COCA-COLA FOUNTAIN EQUIPMENT BULLETIN..... SERVICE

NUMBER : SERV - #195

SUBJECT : ABS Lift Cylinder Sensor Diagnosis

Figure 1: old switch bracket

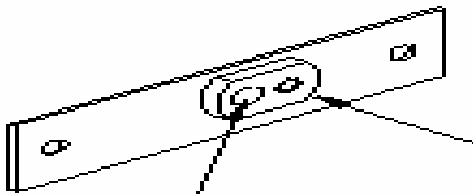
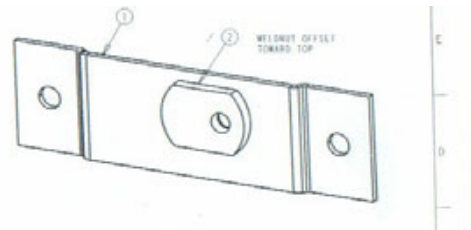
The current switch bracket on the lift cylinder may compress the switch between the bracket and cylinder causing the contactors inside the switch to bind. A new switch bracket has been created which is not subject to this compression.

- 1) Is the switch bracket the old (Figure 1) or the new (Figure 2) configuration?
- 2) Binding can occur on the old switch when the bracket warps (Figure 3) and the switch comes in direct contact with the cylinder. Warping is caused by over-tightening the screws on the bracket. If you have an old switch bracket, make sure that there is a gap between the switch and cylinder. You can do this using a dollar bill or similar small piece of paper (see Figure 4)
